1950 SUPPLEMENT TO
SCREW-THREAD STANDARDS
FOR FEDERAL SERVICES
1944

Prepared by direction of the
Interdepartmental Screw-Thread Committee
and superseding the Supplement issued June 15, 1949

[Issued March 20, 1951]

FIGURE 20.—Thread form of thread plug and ring gages.

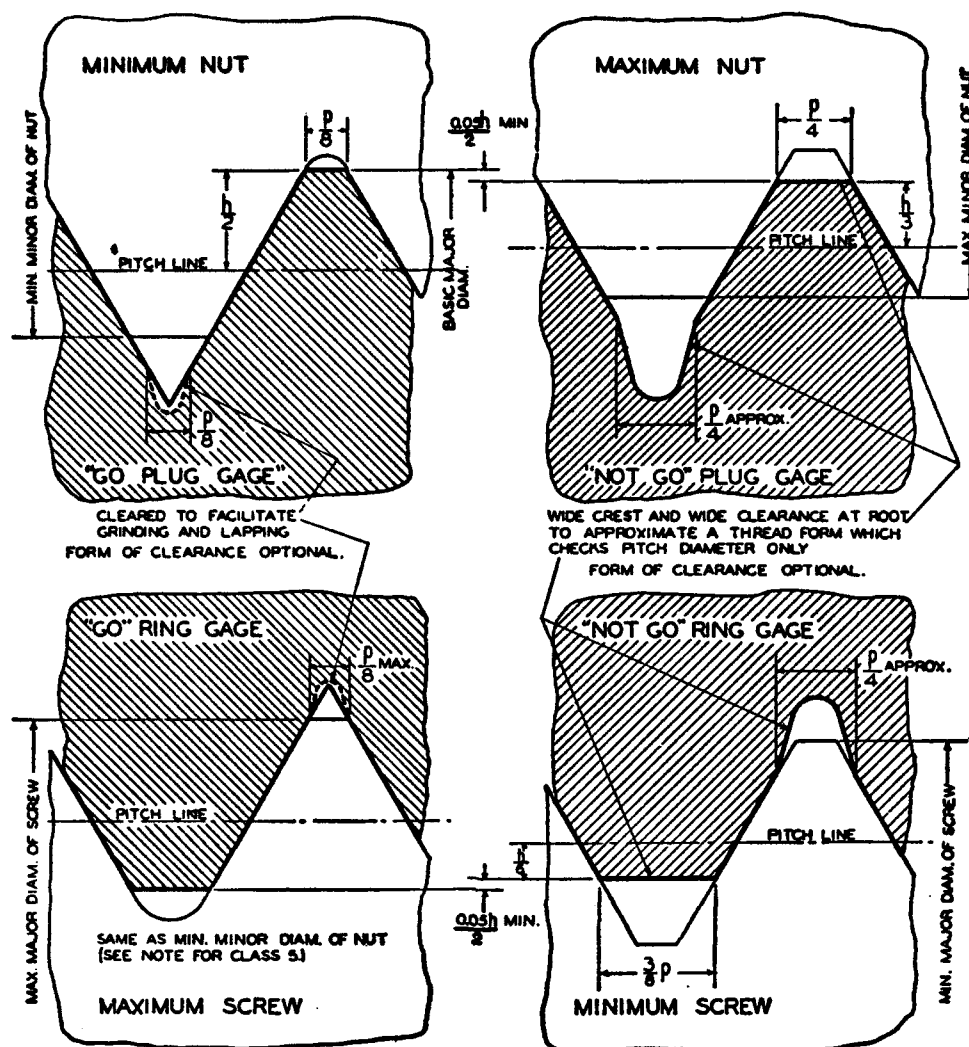
Pages 31 to 34, "1. GAGE TOLERANCES", revise to read as follows:

FIGURE 21.—Thread form of maximum-metal and minimum-metal limit thread setting plug gages.

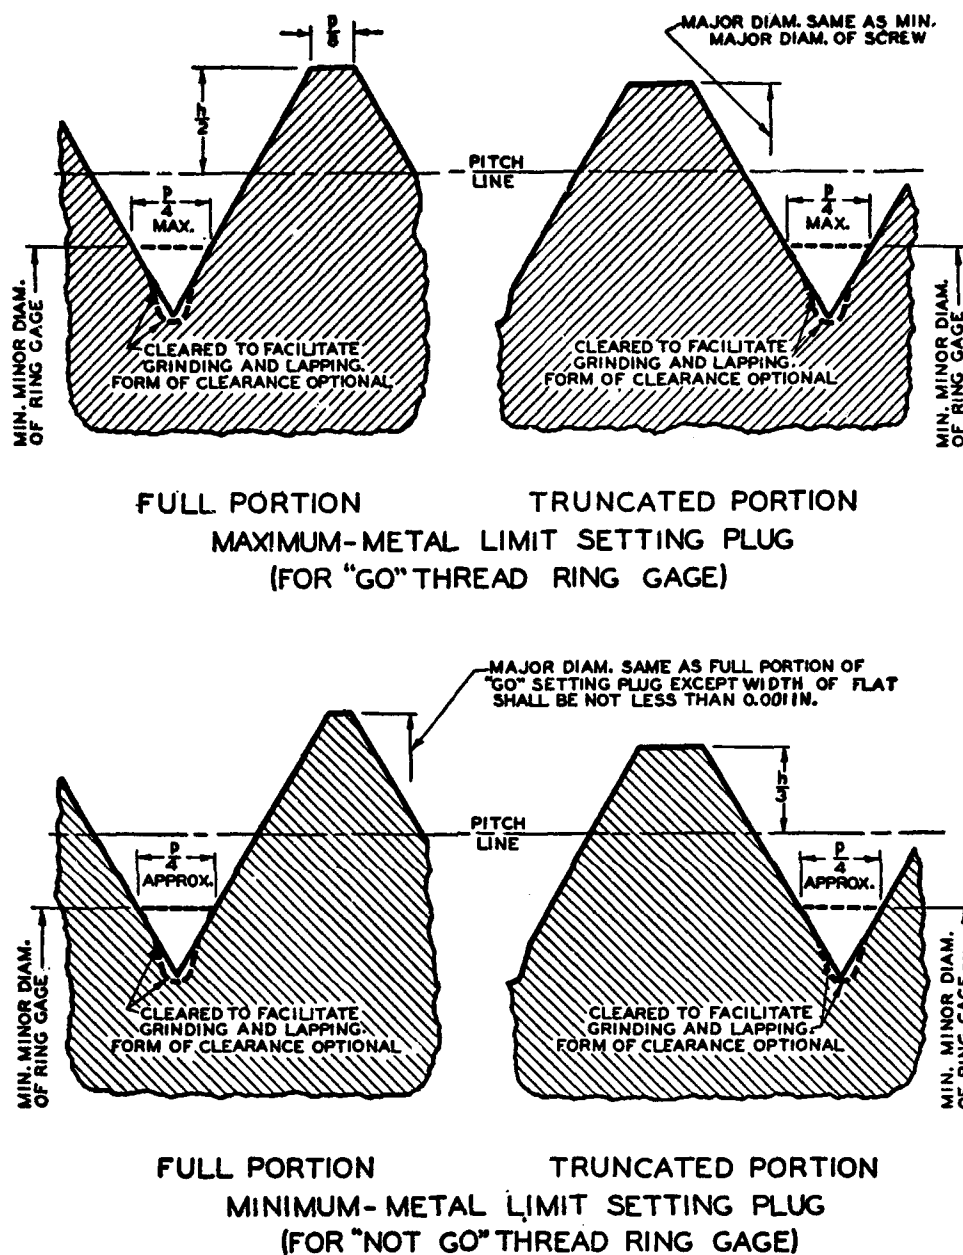
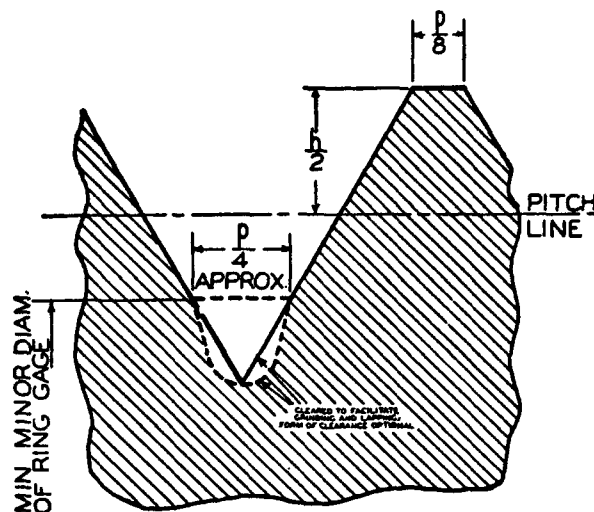
3. THREAD FORM OF SETTING PLUG GAGES.—The specifications for thread form of setting plug gages are stated in detail below, and are summarized in table 8 and figures 21 and 21A.

FIGURE 23. American Standard taper pipe thread notation.

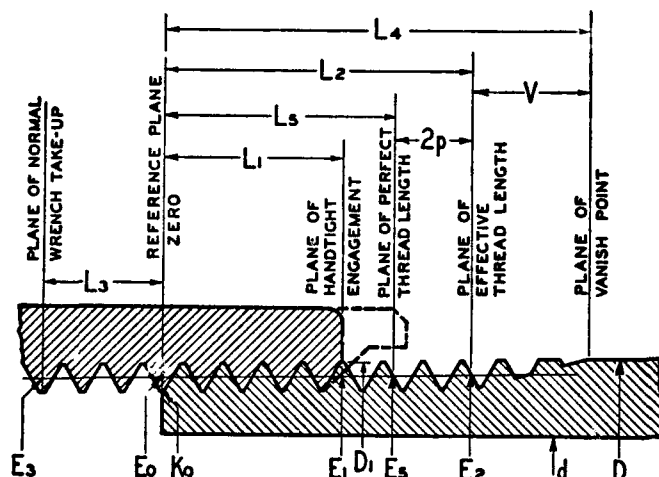
Page 118, figure 23, revise as follows:

FIGURE 26A. Methods of dimensioning taper pipe thread gages.

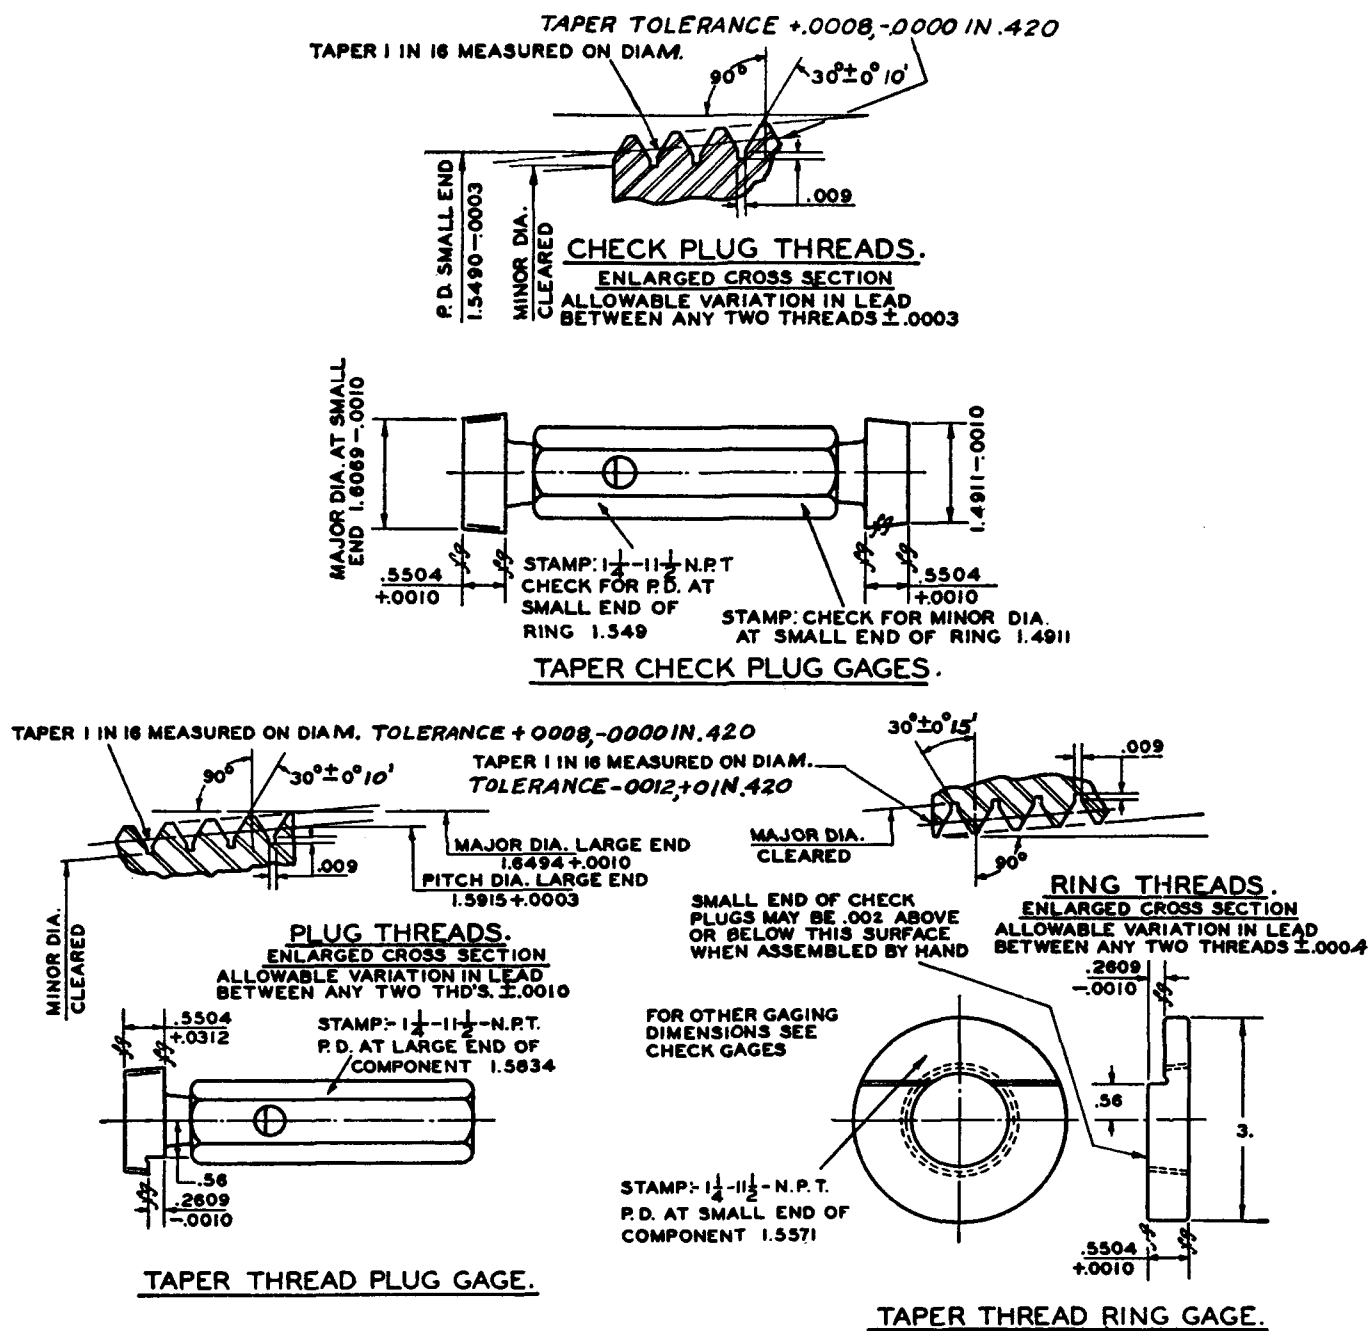
Page 123. Insert figure 26A, as follows:

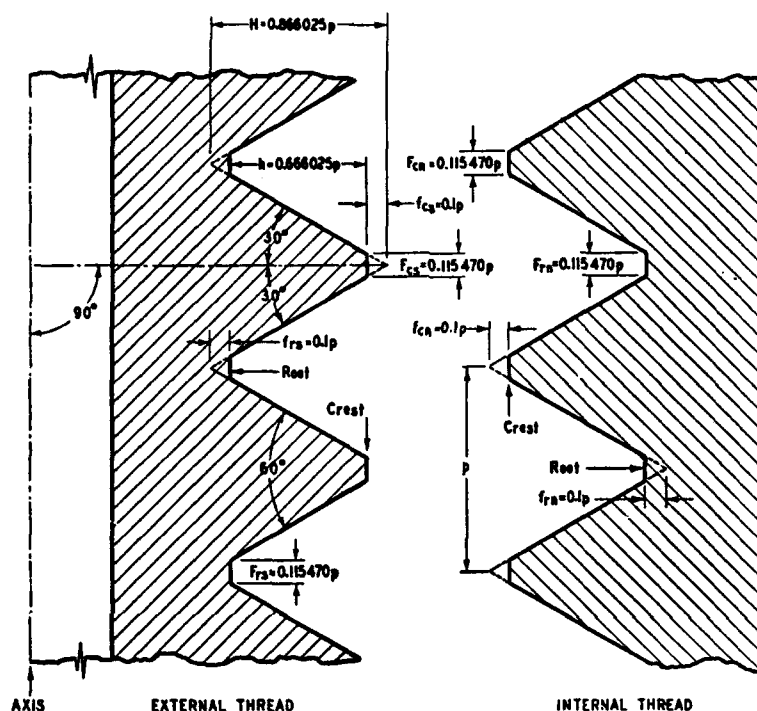
Page 136, table 72, add to table heading, "NPSM," and insert the following illustration:

On page 137, table 73, add to table heading, "NPSL," and insert the above illustration, as indicated for table 72.

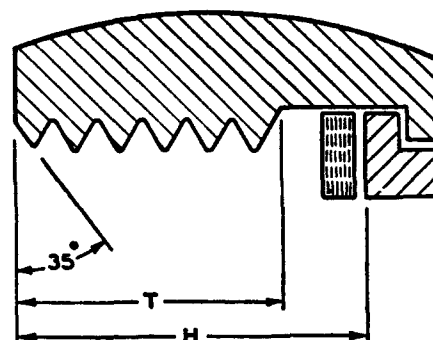
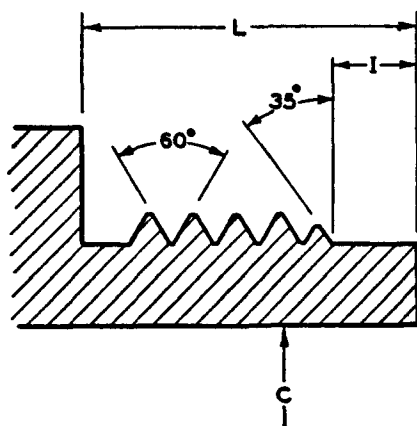
Page 144, table 78, revise illustration to show truncated threads, thus:
